ADDENDUM NO. 3

PROJECT #21030 - Jefferson Co. Jerry Ware Terminal and ARFF Station Rehabilitation BEAUMONT, TEXAS

Sheet E9.1- Revised and Attached

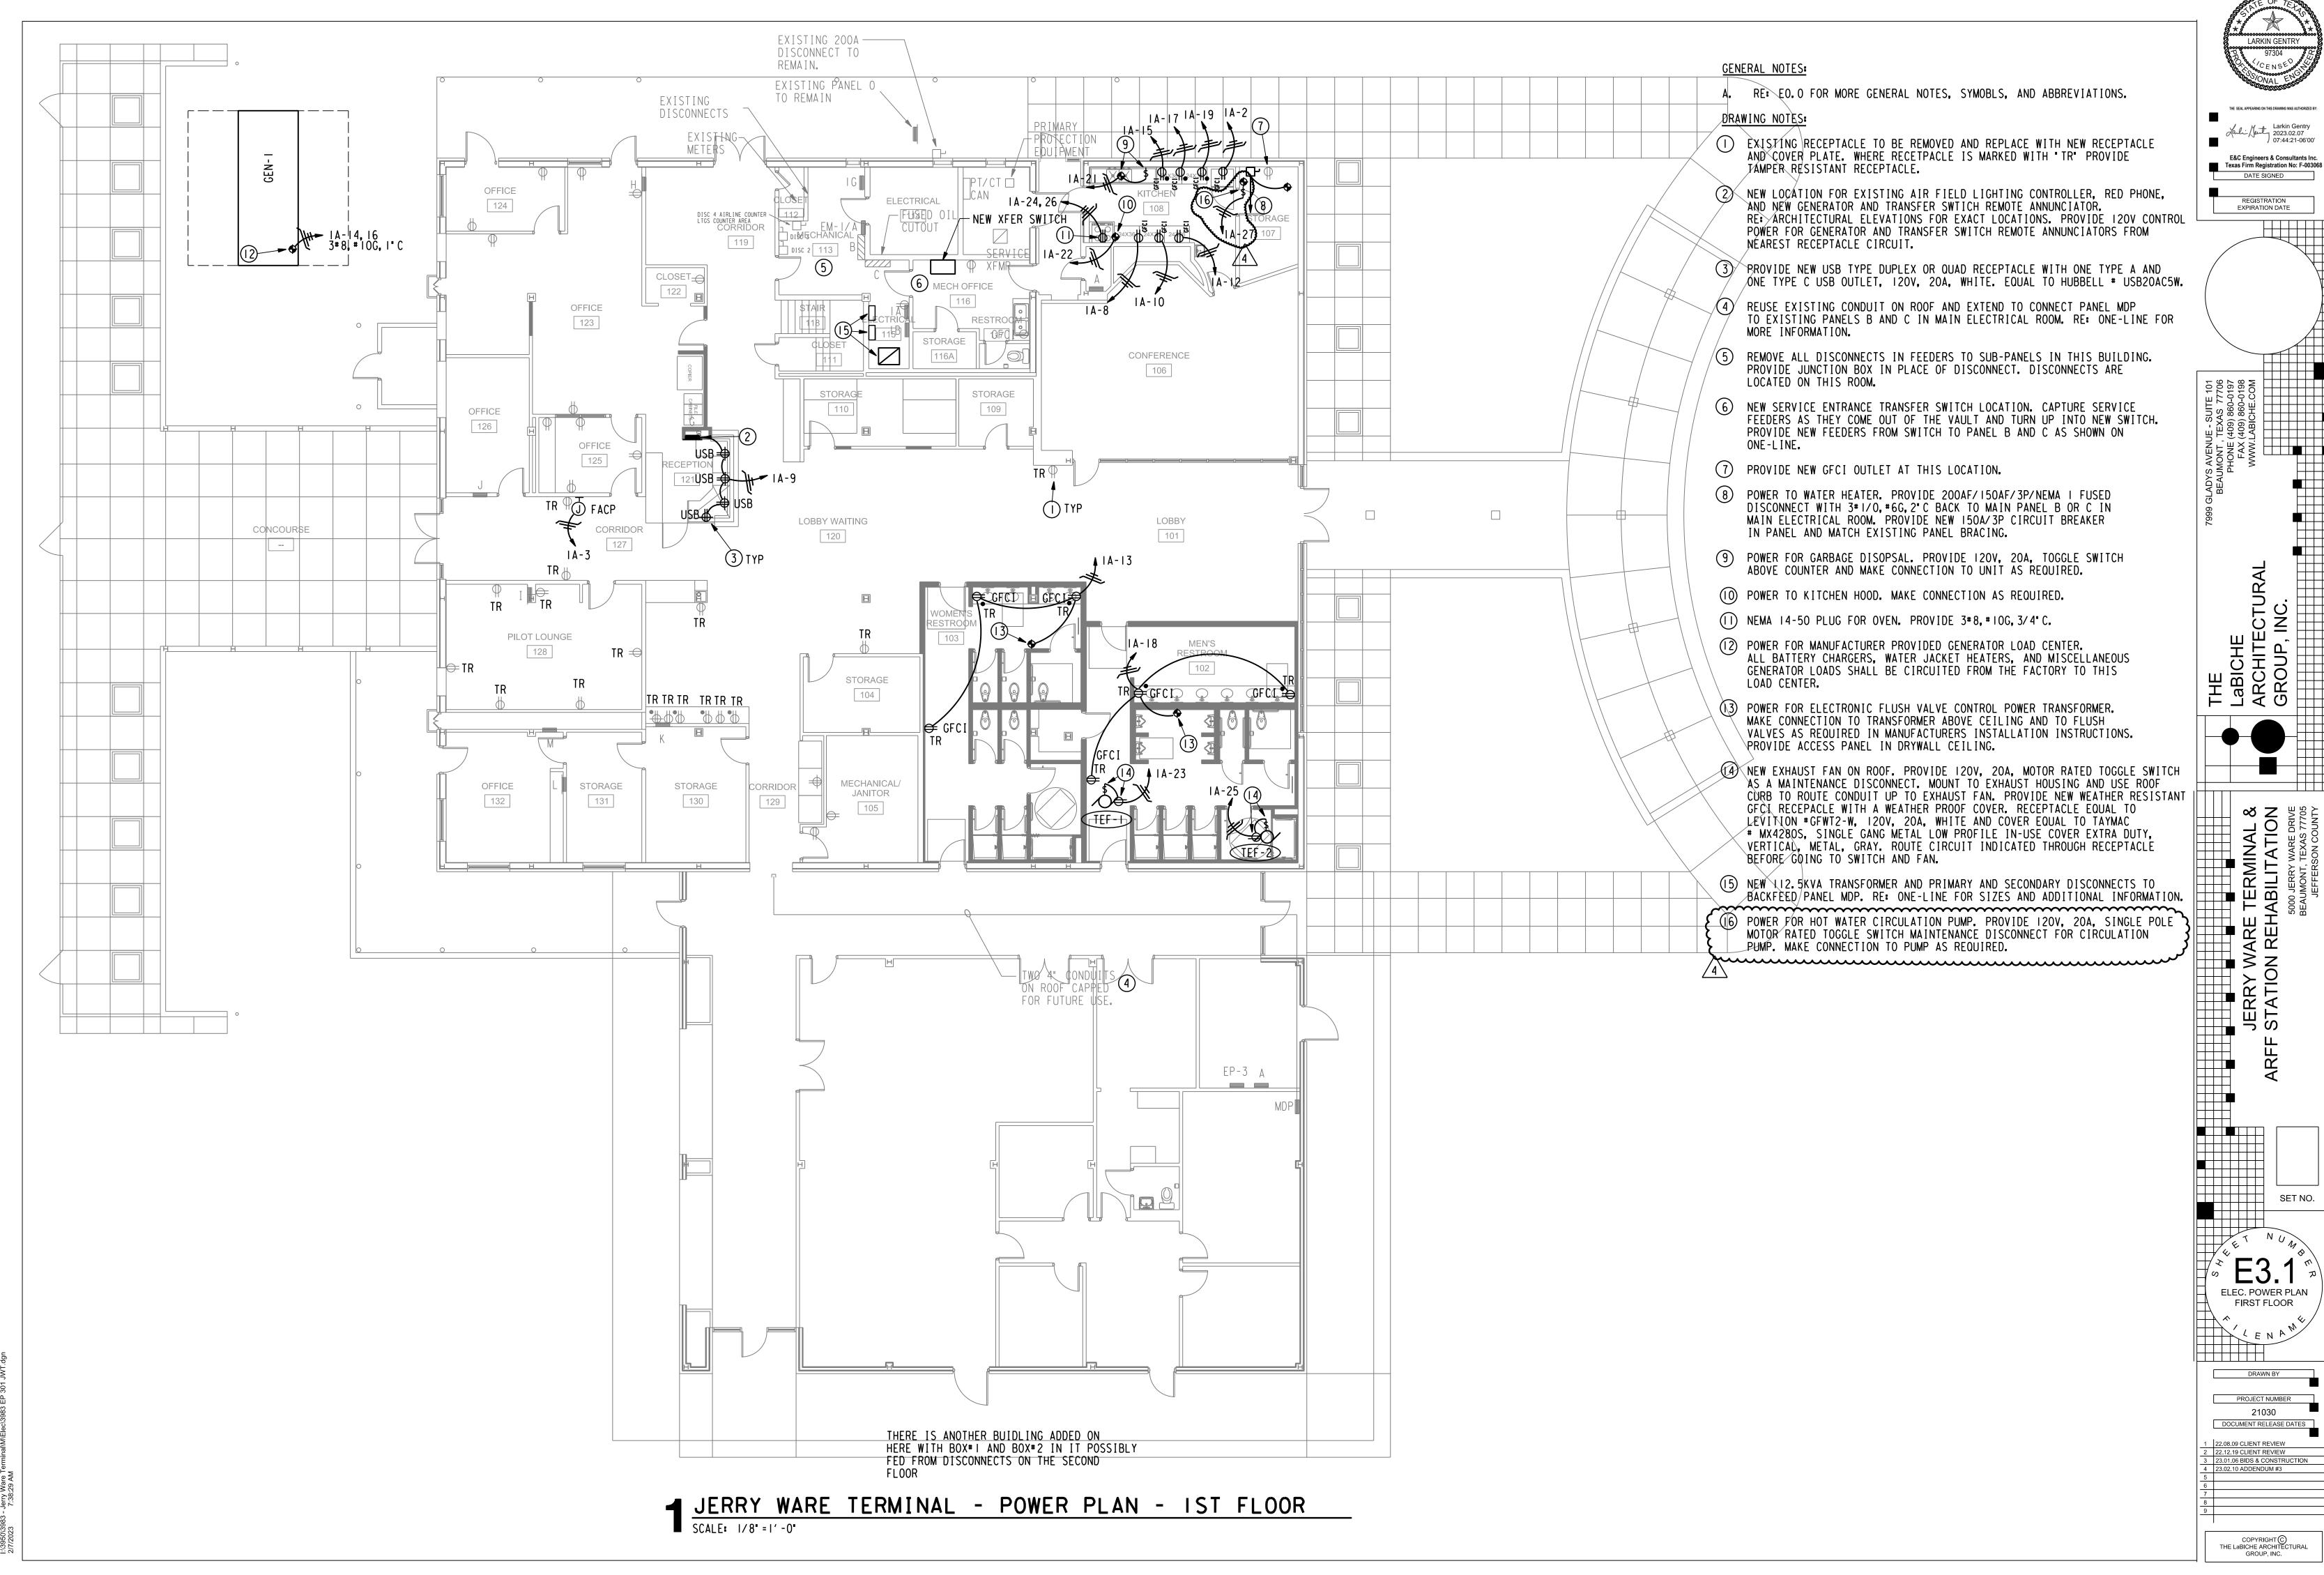
Panel Schedule – Panel 1A

1. See circuit added to Panel 1A, Circuit 27 for power to hot water circulation pump.
